Comhairle Chontae Atha Cliath Theas

Record of Executive Business and Chief Executive's Order

Reg. Reference: SD22A/0095 **Application Date:** 04-Apr-2022
Submission Type: New Application **Registration Date:** 04-Apr-2022
Correspondence Name and Address: Kane Architecture 6, Clarinda Park North, Dun Laoghaire, Co. Dublin
Proposed Development: 2 storey dwelling with mono pitched roof and ancillary site works to side of existing house.
Location: 50A, Springvale, Edmonstown Road, Rathfarnham, Dublin 16
Applicant Name: Brian Sheridan
Application Type: Permission

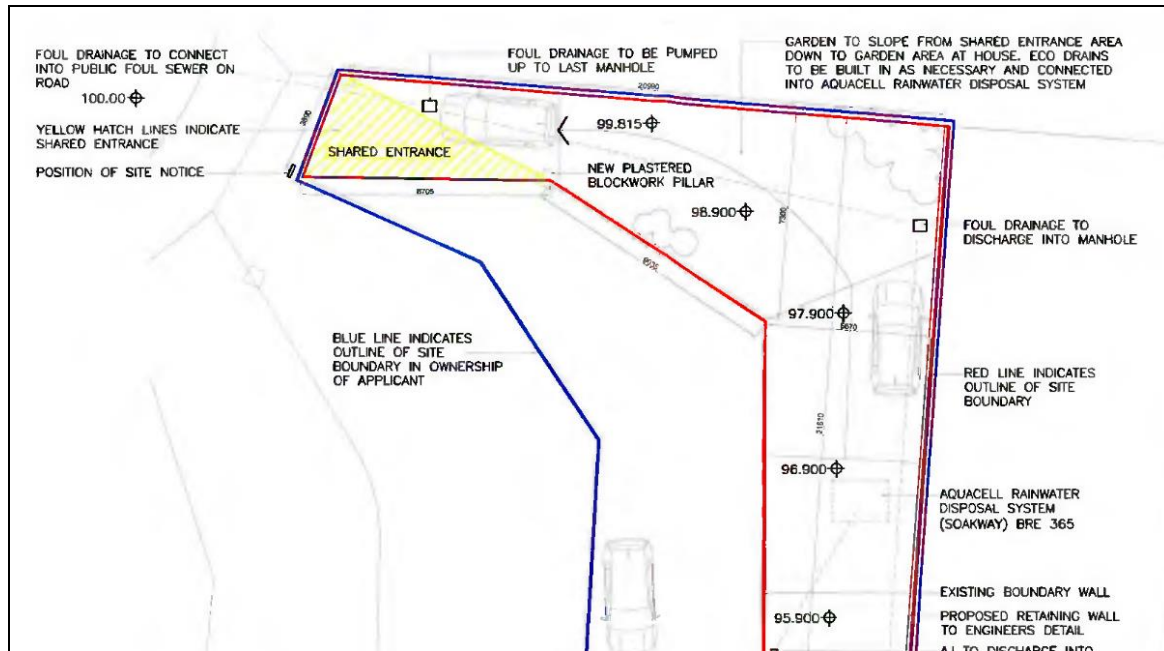
The applicant has submitted drawings showing a proposed shared vehicular access arrangement between the existing No. 50A and the proposed No. 50B with an entrance width of 3890mm.

This would result in a vehicular entrance being shared by 3 properties. SDCC Roads Department considers this an inappropriate combined vehicular entrance at a constrained site which would compromise the safety of pedestrians and drivers. This constitutes a traffic hazard.

Roads recommends refusal.

1. The proposed development would intensify the use of an existing shared access, increasing the risk of a traffic accident, thereby endangering public safety by reason of a traffic hazard.
